December 30, 2024

MEMORANDUM

RE: Pine 43 West – CR-2024-0003

PROJECT INFORMATION

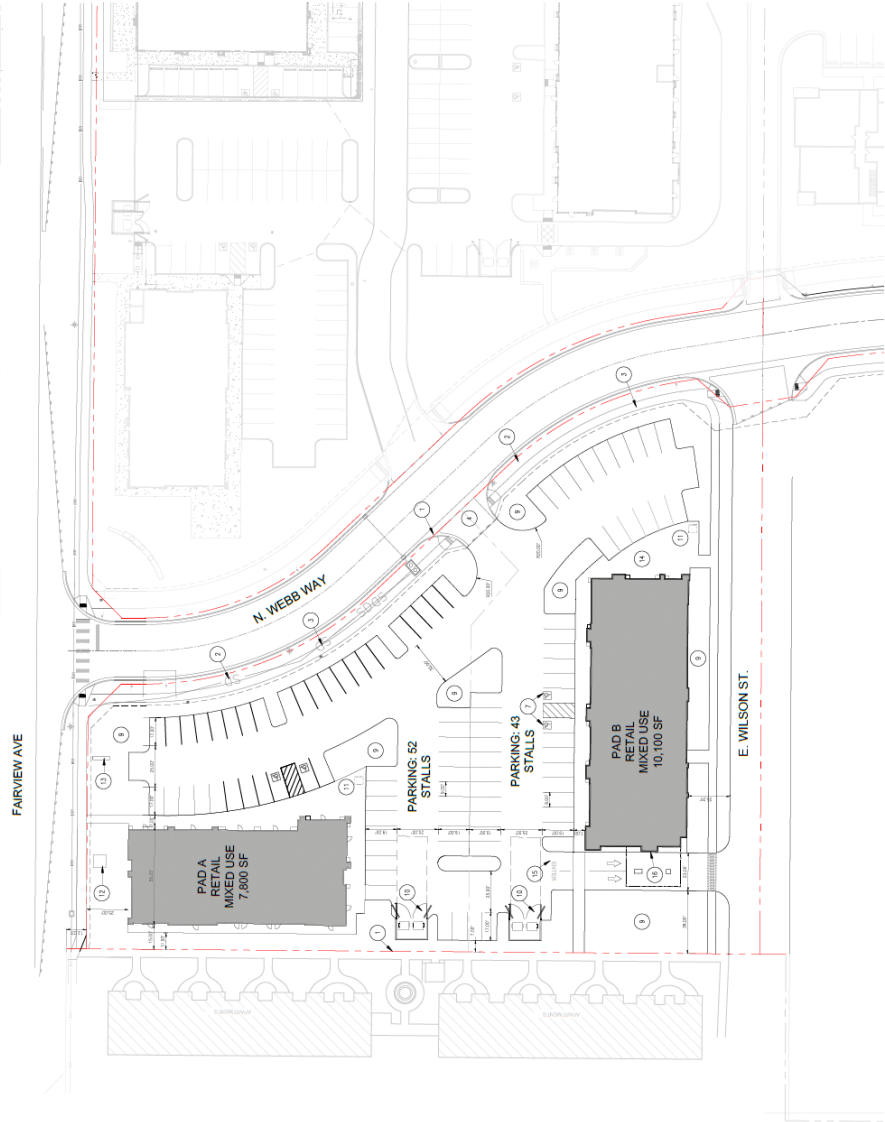
Approved Use: The drive-through is for a restaurant which is planned in the western-most tenant space of a new 10,100-square foot multi-tenant building on the southern portion of the site on Pad B (see site and landscape plans below). The drive-through was approved for pick-up service only; a menu board and/or speakers was not approved.

Applicant Request: The Applicant requests City Council approval of a reduced buffer width of 7-feet adjacent to parking and 10-feet adjacent to the rear of the future single-story building on Pad A with a reduced building setback of 15-feet. The reason for the request is due to the alignment of N. Webb Ave. along the site's east boundary – it shifts abruptly to the west as it intersects with Fairview Ave. in order to align with the access point on the north side of Fairview, which reduces the width of the northern portion of the parcel by more than half of the southern portion of the parcel. The proposed site layout, with the building along the west boundary, provides an added buffer and screening between the adjacent residences and the parking area.

OVERALL LANDSCAPE PLAN

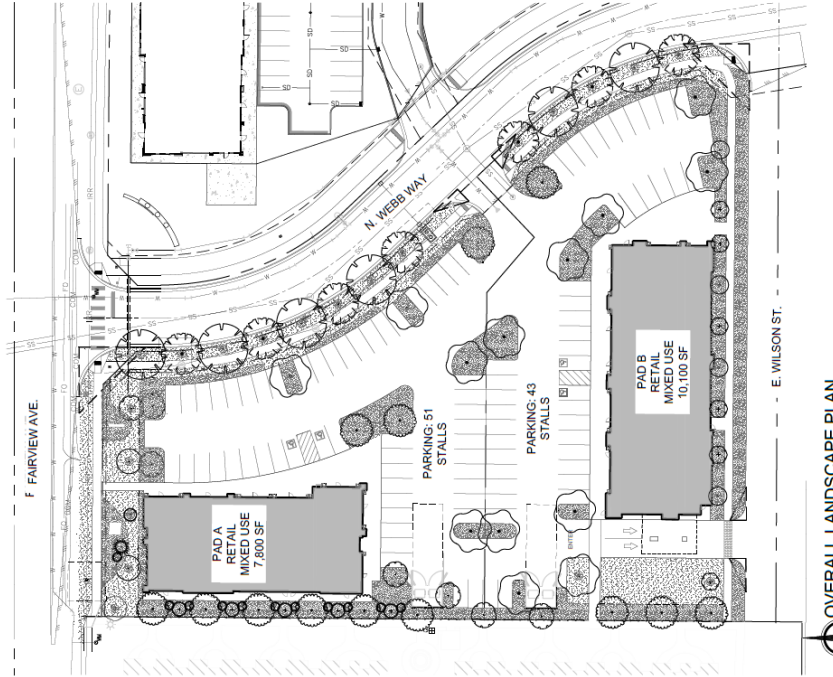
UDC Requirements: The UDC (Table 11-2B-3) requires a 25-foot wide landscape buffer to residential uses on C-G zoned property sharing a contiguous lot line with a residential use; landscaping is required within the buffer in accord with the standards set forth in UDC 11-3B-9C. Because the abutting property to the west contains a multi-family residential use and the subject property consists of one (1) parcel of land, a buffer is required along the entire western boundary of the site. However, the UDC does allow the width of the buffer to be modified by City Council at a public hearing with notice to surrounding property owners; a reduction in the buffer width does not affect building setbacks – all structures are required to be set back from the property line a minimum of the buffer width required in the district (i.e. 25'), per UDC 11-3B-9C.2.

Staff is in the process of proposing an amendment to the UDC, which would allow buildings to encroach in the buffer area if consent from the abutting property owner is obtained *and* if Council grants a reduction to the buffer width. In the interim of a code change, the Director has determined a building can encroach within the required buffer area *if* Council grants a reduction to the buffer width and a reduced setback *and* consent from the adjacent property owner is obtained for the reduced buffer and building setback. A letter of support for the reduced buffer width and associated building setback was submitted from the owner of the abutting residential property provided that a privacy fence and increased plantings are completed along the west boundary of the site, which will provide visual and sound buffering to the residential units.
